SOLANO COUNTY

RE: Solano County Comments on the Draft Bay Delta Conservation Plan (BDCP) / California WaterFix (CA WaterFix) Partially Recirculated Draft Environmental Impact Report and Supplemental Draft Environmental Impact Statement (RDEIR/SDEIS)

Solano County Comments on the WaterFix RDEIR/SDEIS

Figure 1: Daily EC values at Barker Slough from the sensitivity analyses for the period October 1976 through September 1984.

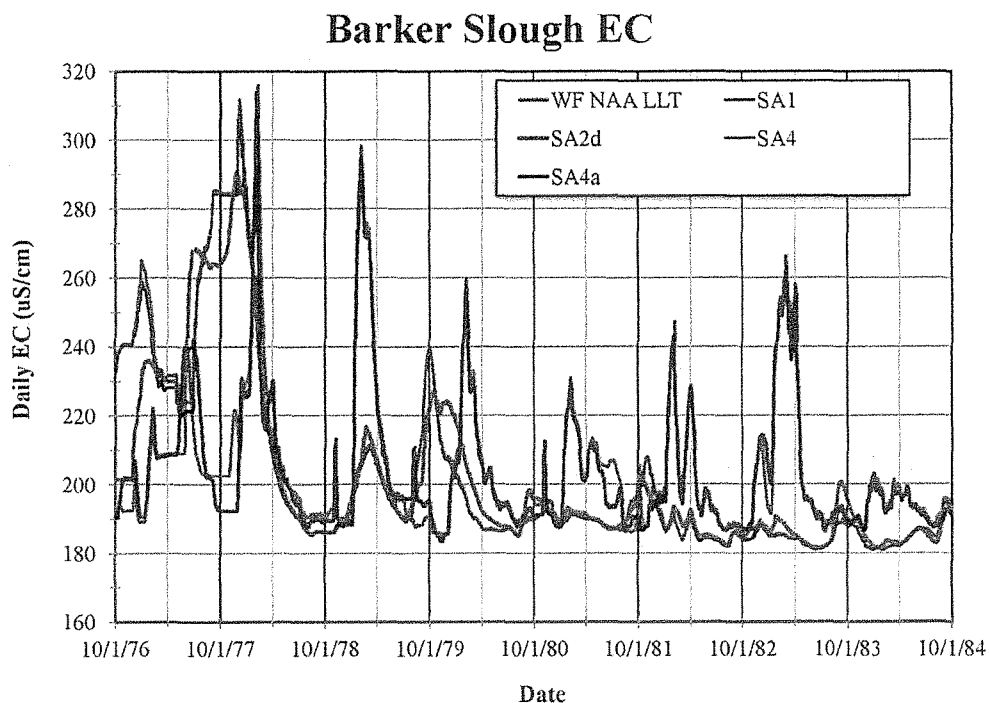
Sensitivity Analyses show a large range of potential water quality impacts at Barker Slough and in Suisun Marsh

The Sensitivity Analyses were based on the flawed modeling for Alternative 4, Scenario H3 at late long term, i.e., 2060 conditions with habitat restoration (which is no longer included with new Alternative 4A), and not updated using the most recent versions of the CALSIMII and DSM2 models. The following two figures show the range of EC at Barker Slough for the following sensitivity analyses used by DWR:

Figure 2: Daily EC values at Barker Slough from the sensitivity analyses for the period October 1984 through September 1991.

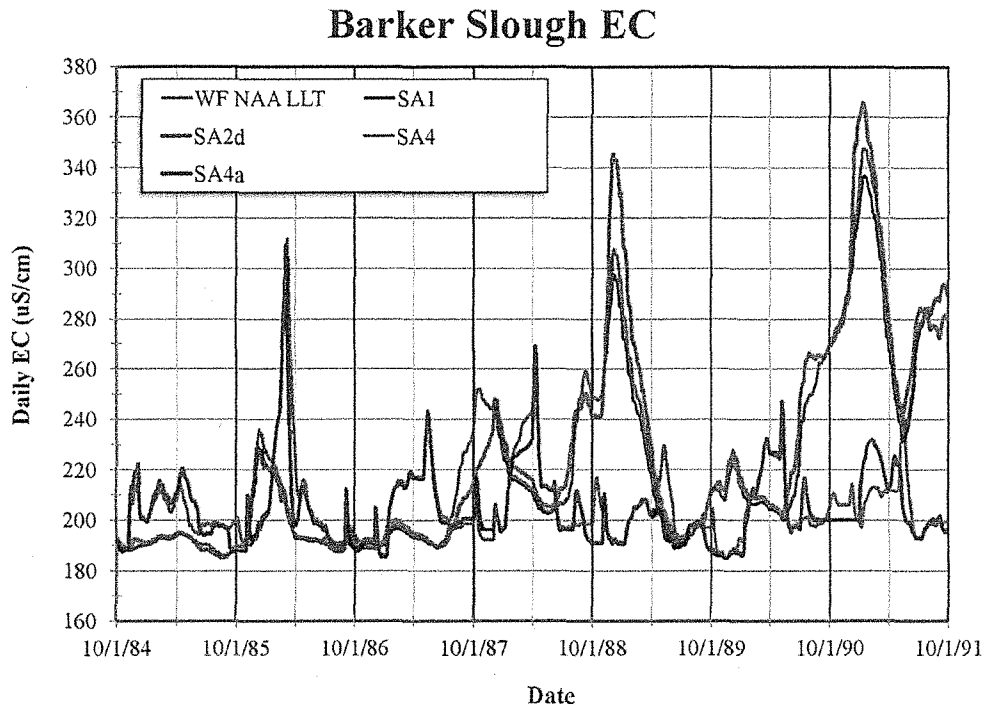
Also plotted for comparison purposes is the No Action Alternative developed for the WaterFix RDEIR/SDEIS for late long term. The WaterFix RDEIR/SDEIS only presented the water quality data as the averages for each month of the year for the short period modeled, water years 1976-1991, and for the water year 1987-1991 drought period. The 1976-1977 drought period was not included in the drought averaging.

Figure 3: Scatter plot of daily EC values at Barker Slough from the WaterFix sensitivity analyses with no restoration (SA4a, LLT) for the period October 1975 through September 1991. Some peak EC are reduced relative to the No Action equivalent but significant adverse impacts occur at other times.

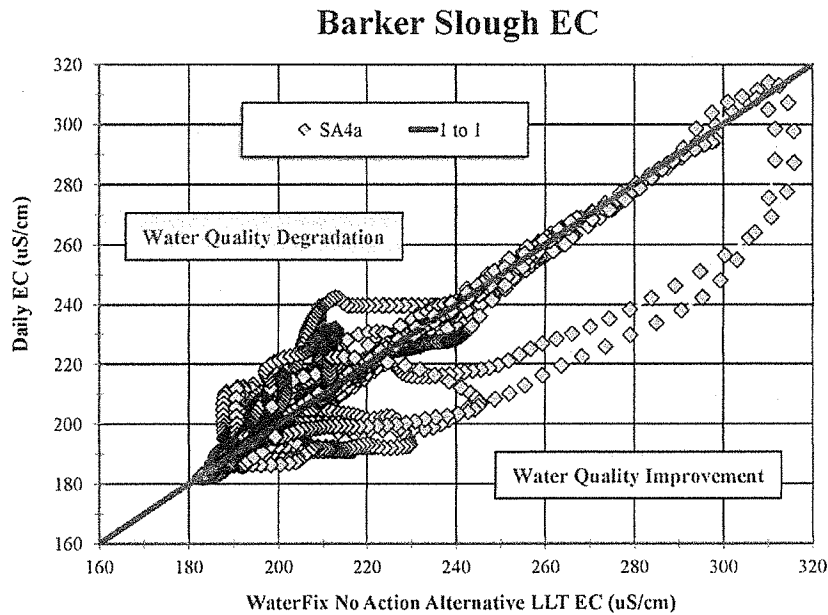
The following figures (Figures 3 and 4) show the EC data for each month of the 16-year sensitivity analysis simulation period (192 data points) in the form of scatter plots. The EC data for Barker Slough and Belden's Landing for Sensitivity Analysis #4 (no habitat restoration) are plotted as a function of the WaterFix No Action Alternative. Both are at late long term.

Some peak ECs at Barker Slough are reduced relative to the No Action equivalent but significant adverse impacts occur at other times. There are some reductions in EC relative to the No Action equivalent at Belden's Landing but significant adverse impacts occur at other times. The presentation of water quality data must present the data in sufficient detail to fully disclose the daily or month to month variations in water quality, in particular the occasions when salinities increase significantly. It is not acceptable to only present long-term averages that obscure and reduce the significant impacts on urban and agricultural water users, and the Delta ecosystem.

The WaterFix RDEIR/SDEIS is inadequate because it fails to present analysis data in a form that discloses the daily or month to month impacts of the proposed project on water quality and fails to avoid or provide definitive mitigation for these significant impacts on water quality.

Figure 4: Scatter plot of daily EC values at Belden's Landing from the WaterFix sensitivity analyses with no restoration (SA4a, LLT) for the period October 1975 through September

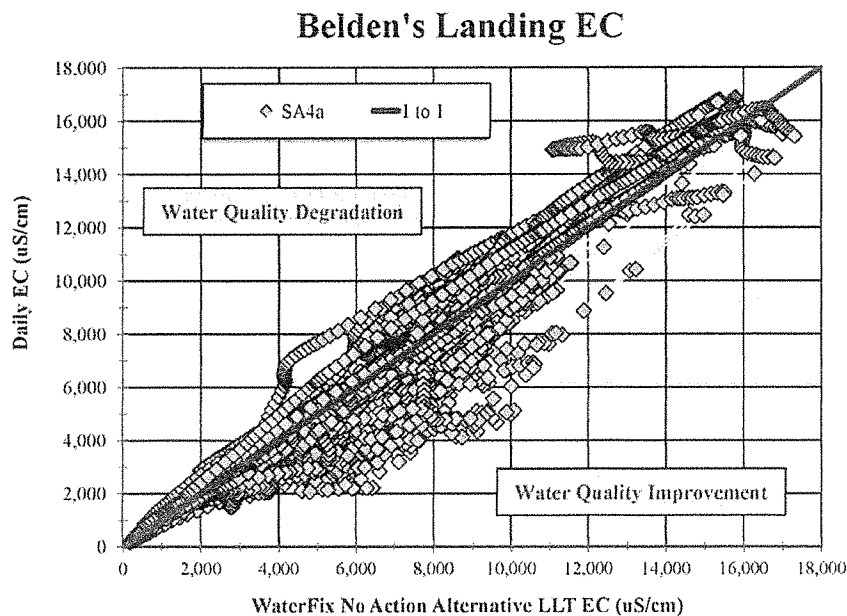
1991. There are some reductions in EC relative to the No Action equivalent but significant adverse impacts occur at other times.
